Docket Item #15  
DEVELOPMENT SITE PLAN #2005-0012  
POLK TOWNHOUSES

Planning Commission Meeting  
June 5, 2007

**REQUEST:** Consideration of a request for a development site plan, with modifications, to construct multi family buildings with townhouses style condominium units on a portion of the site.

**DSP #2005-0012**

Figure 23: Retaining Walls  
Yellow Walls under 10'  
Red Walls over 10'

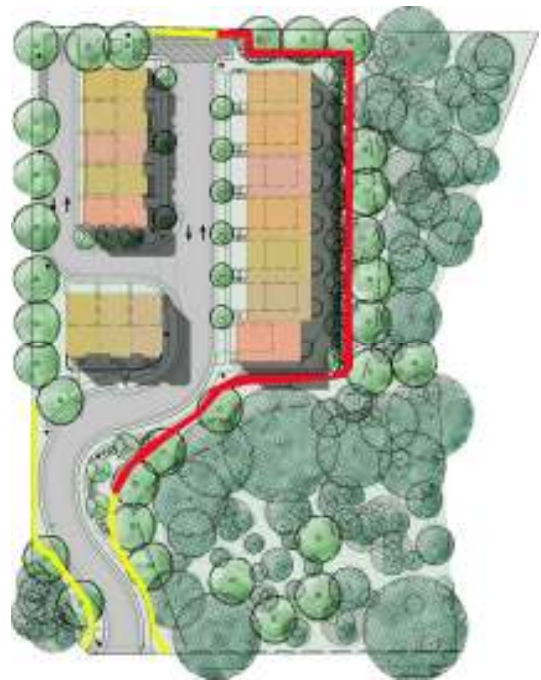
Because of the topography, a series of retaining walls that range from 2 feet to up to 24 feet are proposed for the development. Although most of these walls will not be visible from the surrounding neighborhoods because they are located behind the townhouses, those near the driveway entrance on Polk Avenue will be. The entrance walls range from 2.5 feet up to 10 feet. While ideally the walls would be lower there are some good examples of taller stone walls that have been integrated successfully.

To make the walls at the visible entrance less harsh and more compatible with the surrounding single family and townhouse neighborhood, staff is recommending that the applicant revise the configuration of the entrance and walls to allow for some plantings on either side to soften the walls' appearance. The incorporation of street trees and plantings on either side will create a sense of entry for those residents and visitors and provide an enhanced design/screening for the single-family homes and townhouses on Polk Avenue. Staff is also recommending that the walls adjacent to the entrance be constructed with a high quality natural stone.

Finally, because of the size and length proposed for the retaining walls throughout, staff is recommending a series of conditions regarding their stability and construction, including:

- The design of the retaining walls will be subject to a “third party” structural engineer.
- The proposed design and construction of the retaining walls shall be discussed with the community prior to construction of the retaining walls.
- There will be a warranty for the walls that will be retained for five years from the last certificate of occupancy permit, which equates to about six years from the beginning of construction.
- The walls may be constructed using sheet piles (similar to constructing an underground parking garage) to minimize disturbance of the trees. Additionally, staff will require that the limits of disturbance be cited by a surveyor and maintained through the course of construction to ensure the preservation of the existing vegetation.
